February 22, 2024

Subject: Independent Review of Seismic Stability Analyses Performed by Geosyntec, Lake Petit Dam, Pickens County, Georgia (Schnabel Reference Number 23170093.000)

Figure 2: Deaggregation Plot for 2475-year Return Period, $T = 0.4$ s, Site Class C/D (USGS 2023 NSHM, beta version)

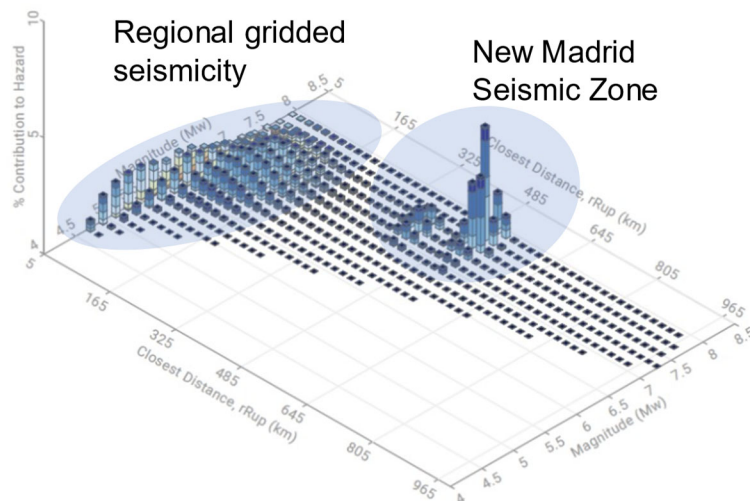
Geosyntec used M_w of 7.0, which is slightly larger than the mean M_w contributing to the hazard at 1.5 T_s . For discussion, Figure 2 shows the deaggregation plot for 2475-year return period, 0.4 s vibration period, site class C/D obtained from the online tool for the USGS 2023 NSHM (beta version). Figure 2 is similar to the equivalent plot for the 2018 NSHM, which has not been included for brevity. Figure 2 indicates that the hazard is influenced by regional gridded seismicity and the further distant New Madrid Seismic Zone. Although a few M_w and distance (R_{rup}) bins for the New Madrid Seismic Zone have the largest individual contribution to the hazard, the cumulative contribution of the local gridded seismicity is significantly greater than the New Madrid Seismic Zone. In this context, M_w of 7.0 is slightly larger than the mean of the contributing M_w for the regional gridded seismicity and less than the contributing M_w of the New Madrid Seismic Zone. In our opinion, M_w 7.0 is a reasonable choice for the 2475-year return period hazard because it is about equal to the overall mean M_w for the hazard. The SDP could consider further sensitivity analyses to assess the effect of a greater M_w in line with earthquakes generated in the New Madrid Seismic Zone, remembering that these earthquakes produce ground motions with smaller contribution to the hazard than the contribution of those produced by regional gridded seismicity.

Figure 3: Undrained Shear Strength Characterization

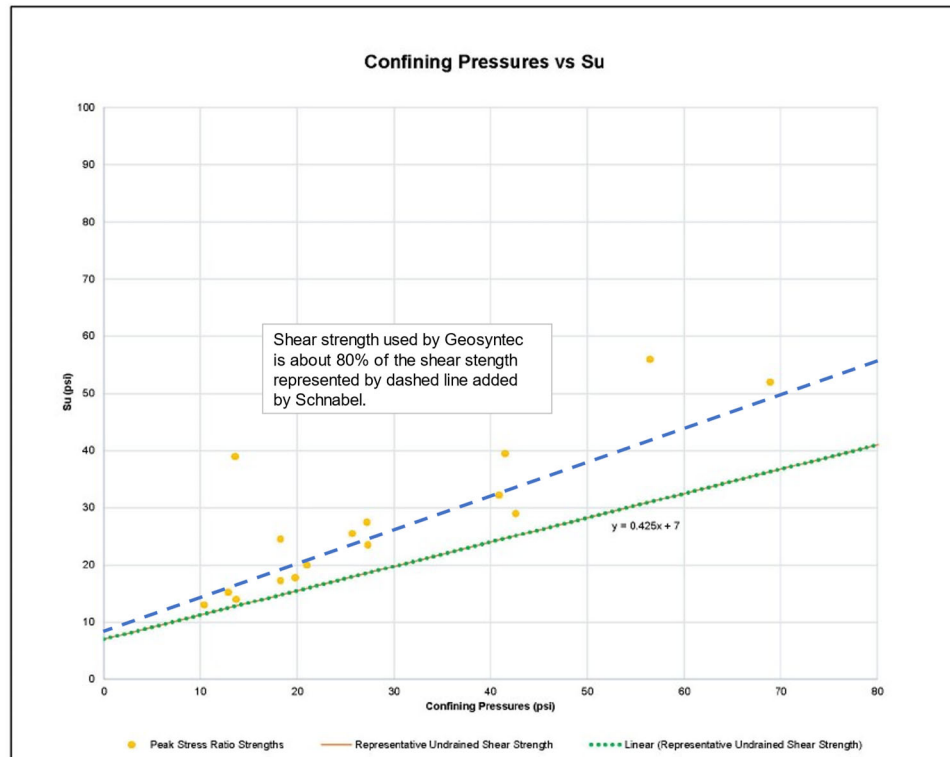
Neither Bray and Travararou (2007) or (2009) mention a specific strength reduction factor, but in our opinion, it is typical practice to select conservative undrained shear strength parameters. Figure 3 shows that Geosyntec selected a lower bound undrained shear strength based on their laboratory data. For reference, the dashed line shown in Figure 3 was added by Schnabel at 1.25 times the Geosyntec strength (i.e., the Geosyntec strength is 80% of the dashed blue line). Visually, the dashed blue line appears to be a reasonable fit to the laboratory data, which suggests that Geosyntec’s undrained shear strength characterization is generally consistent with the dynamic yield strength recommended by Makdisi and Seed (1978).
